# MERCUISER SERVICE BULLETIN

Section: XII (Bulletins)  
Number: 68-15-10  
Date : 5/29/68

- A. Hydraulic Pump Test Gauge Assembly (P. 86 of Section X)
- B. MerCruiser II Bearing Lock Tab Washer Change (PP 44-46 Sec. IX)
- C. Replacement Drive Shaft Housing - MerCruiser IA (P. 39 Sec. IX)
- D. MerCr. I Reverse Hook Release Mechanism Change (P. 14A Sec. II)
- E. MerCruiser II (1.78:1) Outer Transom Plate Change (Section II)
- F. Removing Fast Idle Cam Lever Screw & Spring - V-8's (Sec. VII)
- G. Power Trim Operation (For Miscellaneous Section X)

Figure 2 Swaging Tool C-91-53122

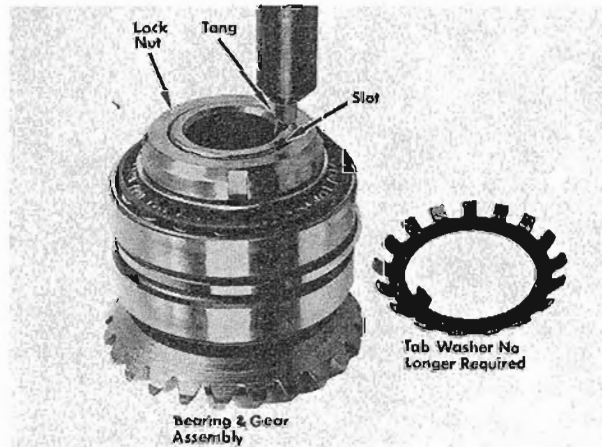
The use of drive shaft gear bearing lock nut tab washer C-14-32054 may be discontinued on earlier gear assemblies. The lock nut now is installed with chamfer up and secured with Swaging Tool (C-91-53122). (Figure 2) To swage lock nut, place tool on edge of lock nut, tang in gear slot; then, strike tool with a sharp blow. Lock nuts may be reused and reswaged in repairs, whereas, the tab washer may not be reused.

Figure 3. Reverse Hook Location

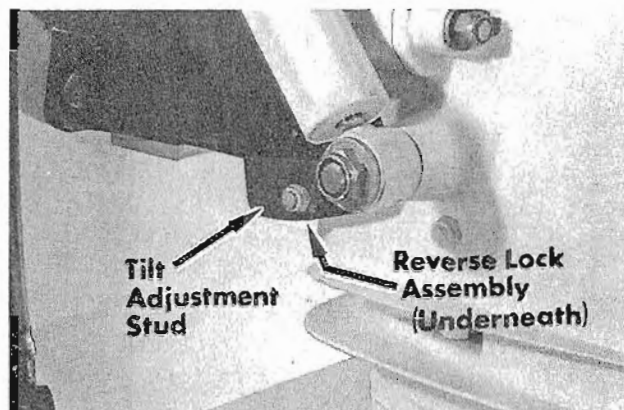
Reverse hook release mechanism no longer can be installed on service replacement bell housing B-52384A1. To release the stern drive unit, if necessary, press the reverse hook assembly down, away from tilt adjustment stud. (Figure 3)
